Immersed Tunnel - Center of River Channel - No Vertical Limit

The IBR comparison of “Existing vs. Proposed Horizontal and Vertical Navigation Clearance” distorts the height of a high bridge. Vehicles will need to climb to 150 feet over the Columbia River, the steepest 4% dangerous interstate bridge.

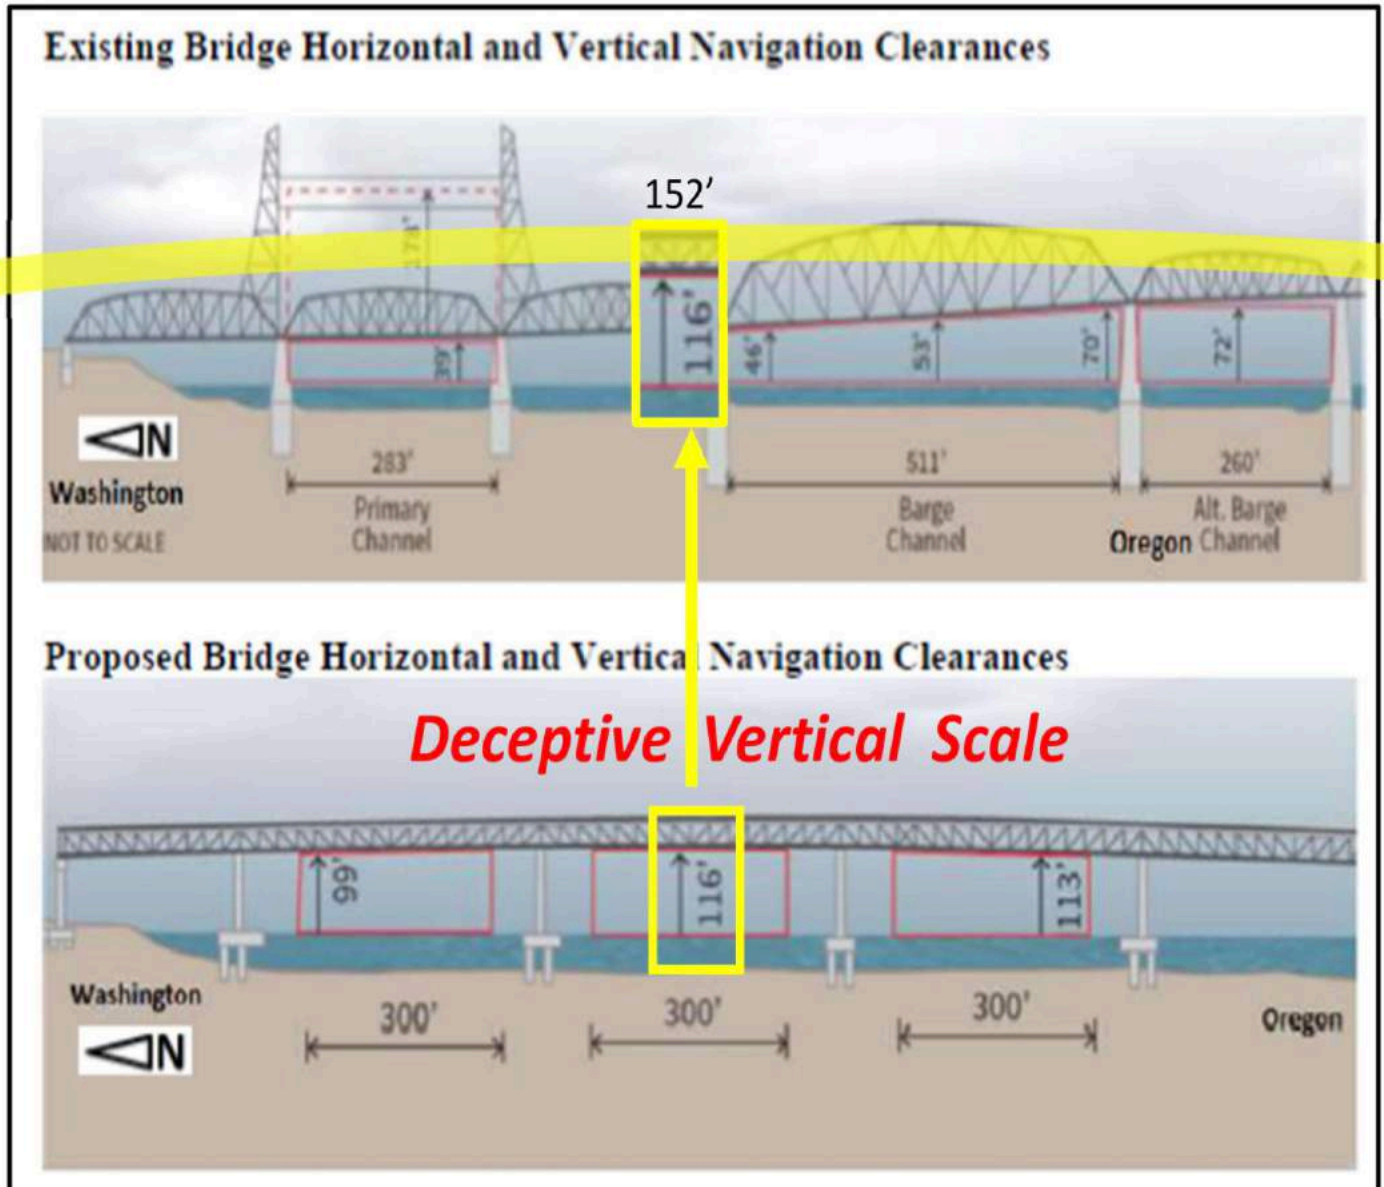
The IBR has spent \$35 million resurrecting the CRC design. Bridge clearance submitted to the US Coast Guard is exactly the same as the 2013 CRC design.

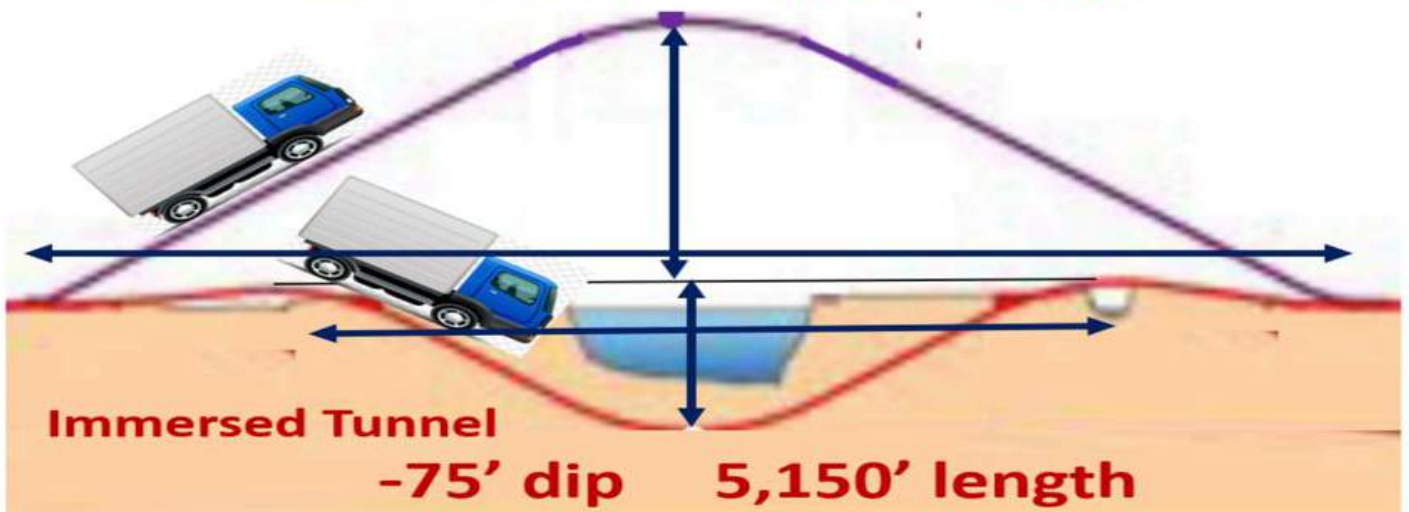
IBR's lie will increase costs by \$1 billion for unnecessary half-mile elevated bridge interchanges connecting +100' at the riverbank.

“A tunnel cannot be feasibly built within the footprint of I-5 without eliminating important connections to SR-14, downtown Vancouver, and Hayden Island.”

An immersed tunnel emerges near the riverbank & connects to current interchanges for SR-14, Vancouver, & Hayden Island

Hayden Island/Marine Drive
Design Option 1: Full Interchange \$5 Higher Construction Cost

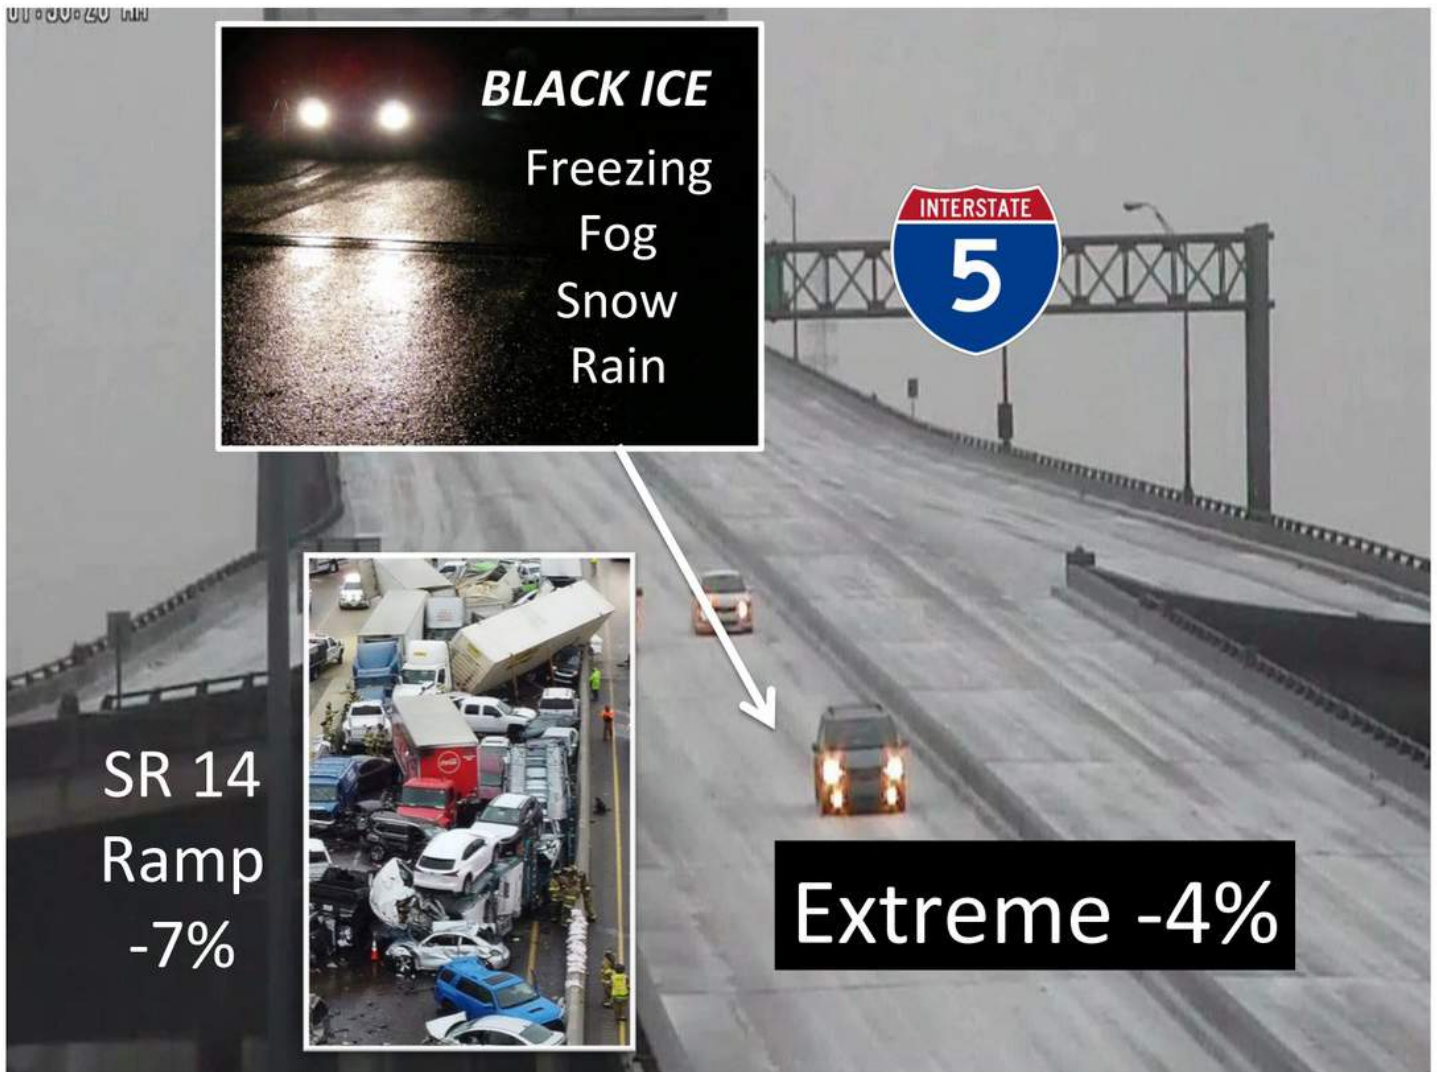
The IBR released graphics of Hayden Island & Vancouver interchanges. They look just like the 10 yr old CRC designs.

These massive elevated interchanges are unnecessary. An immersed tunnel emerges at ground level and can connect to current interchanges.

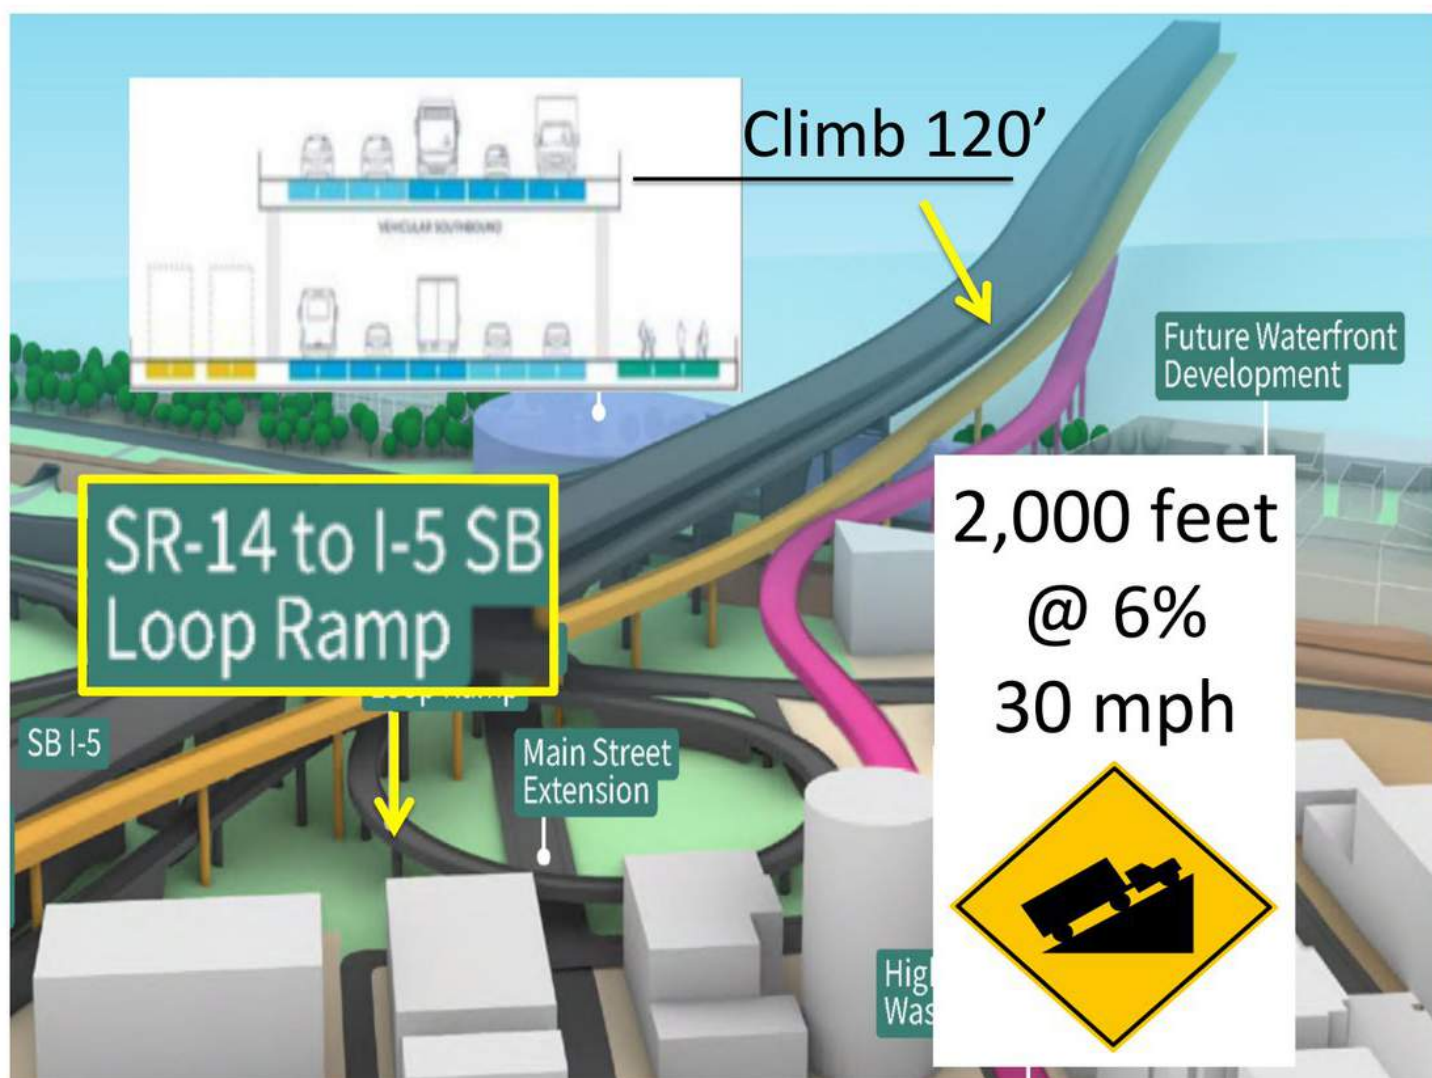
The IBR's bridge will be deadly, the steepest 4% interstate bridge in the country. More deadly will be the 7% downhill off-ramp to SR-14 with possible black ice 6 months a year.

Both IBR bridge designs will rebuild this Loop Ramp, at 2,000-foot, 6% uphill grade, decelerating trucks to 30 mph, dangerous!

The IBR Two Bridge Option will devastate Vancouver

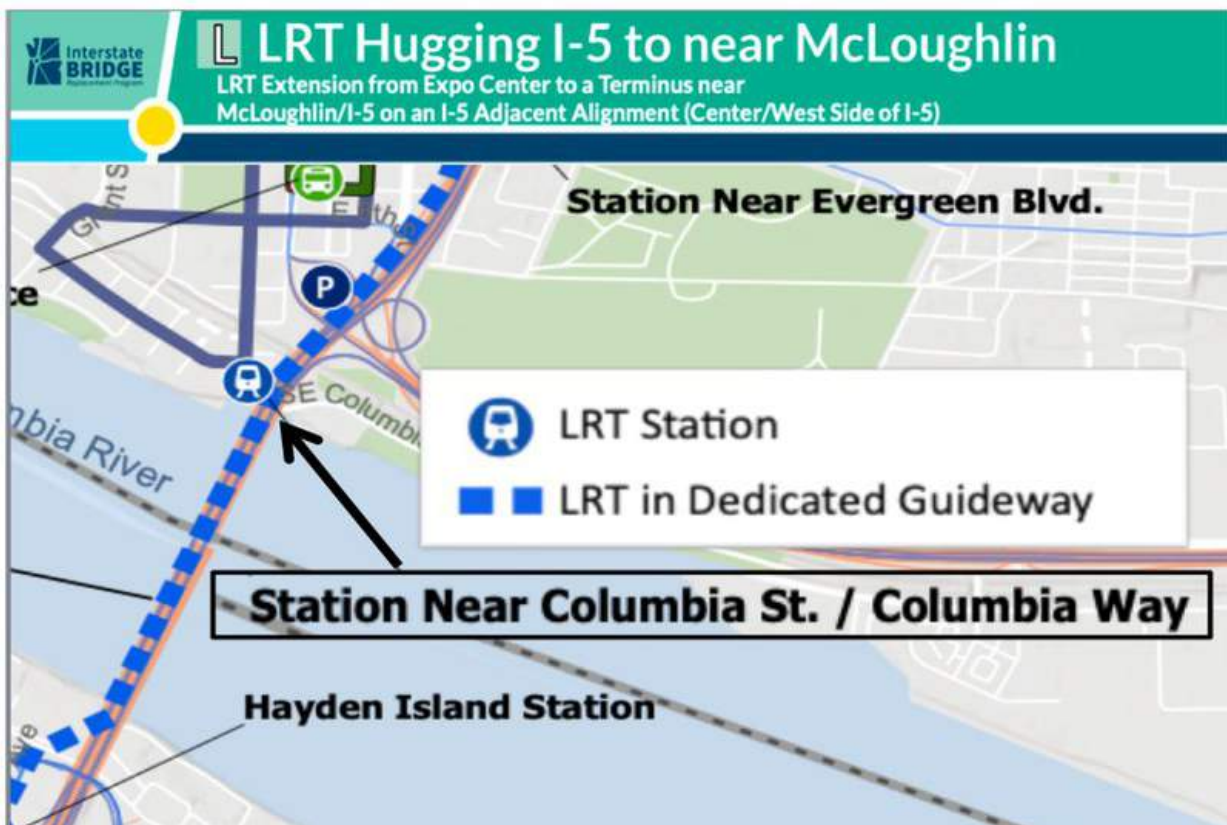
IBR's (LRT) station at Columbia St./ Columbia, at 110 feet will be one of the tallest buildings on the Vancouver waterfront, and require an eight-story elevator. Not practical.
